STAFF RECOMMENDATION
2410 9th Avenue South
May 20, 2020

Application: New Construction—Addition and DADU; Partial Demolition.
District: Waverly-Belmont Neighborhood Conservation Zoning Overlay
Council District: 07
Base Zoning: R8
Map and Parcel Number: 11801038400
Applicant: Lauren Williams
Project Lead: Melissa Baldock, melissa.baldock@nashville.gov

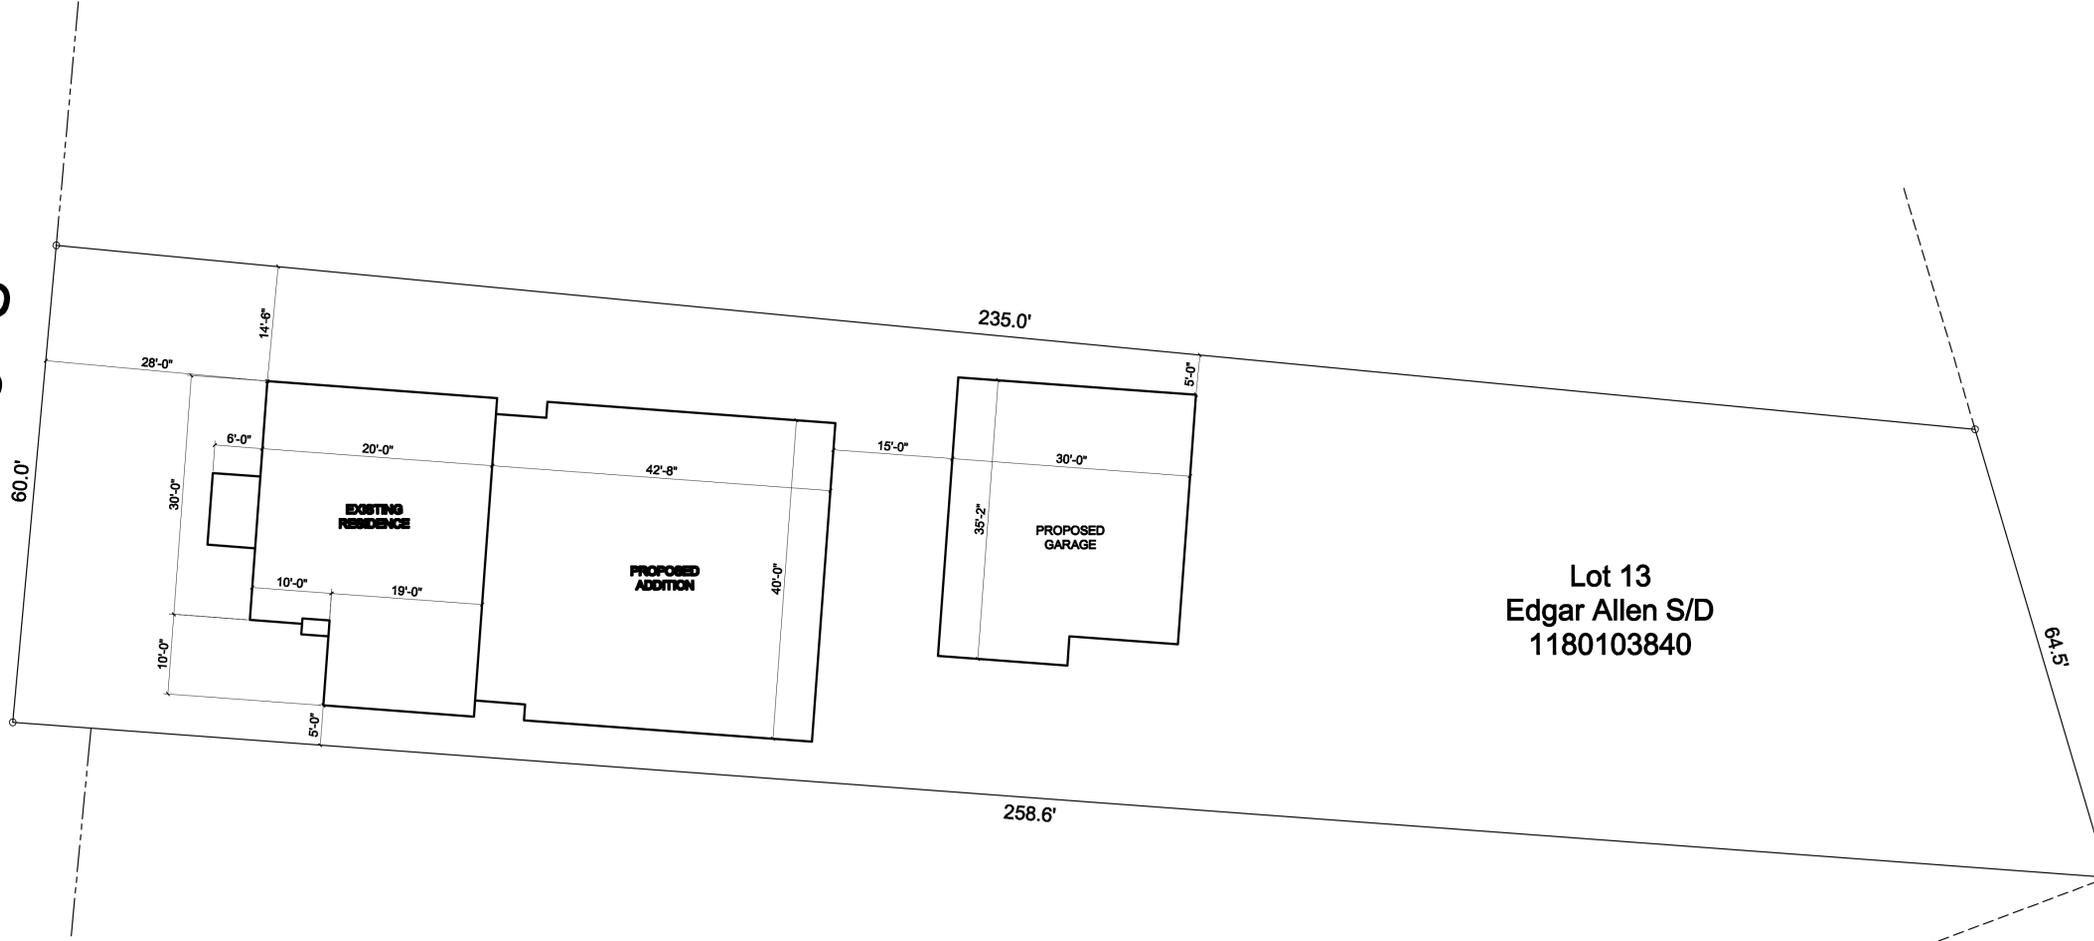
The applicant is proposing just fifteen feet (15') between the back of the house/addition and the outbuilding/DADU. The design guidelines require a minimum of twenty feet (20'). Staff therefore recommends that the garage be pushed back so that it be located no closer than twenty feet (20') from the back of the addition.

With the condition that there be a minimum of twenty feet (20') between the back of the house/addition and the DADU, staff finds that the DADU meets Section III.H.6.d of the design guidelines and Section 17.16.030.G.4 of the DADU Ordinance for setbacks.

Site Plan

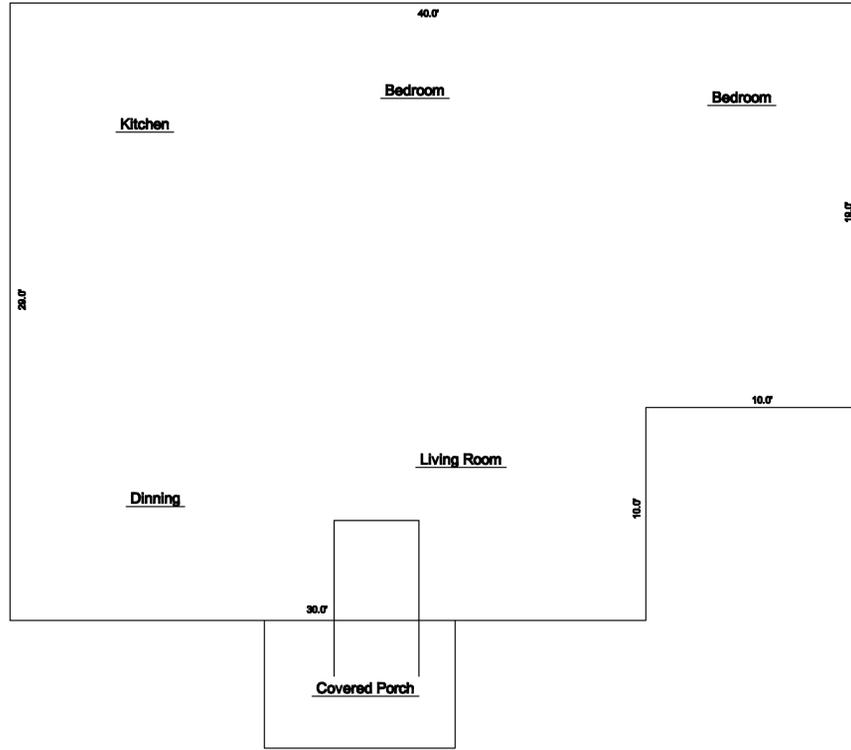
Setback & Rhythm of Spacing: The addition meets all base zoning setbacks. It will be five feet (5') from the right side property line, fourteen feet eight inches (14'8") from the left side property line, and over one hundred feet (100') from the rear property line. The applicant is proposing only fifteen feet (15') between the back of the addition and the DADU/outbuilding. The design guidelines state that there should be a minimum of twenty feet (20') between the back of the house and the garage/DADU. Staff therefore recommends that there be a minimum of twenty feet (20') between the back of the house and the addition.

With the condition that there be a minimum of twenty feet (20') between the back of the house and the addition, staff finds the addition's setbacks to meet Sections III.C. and IV. of the design guidelines.
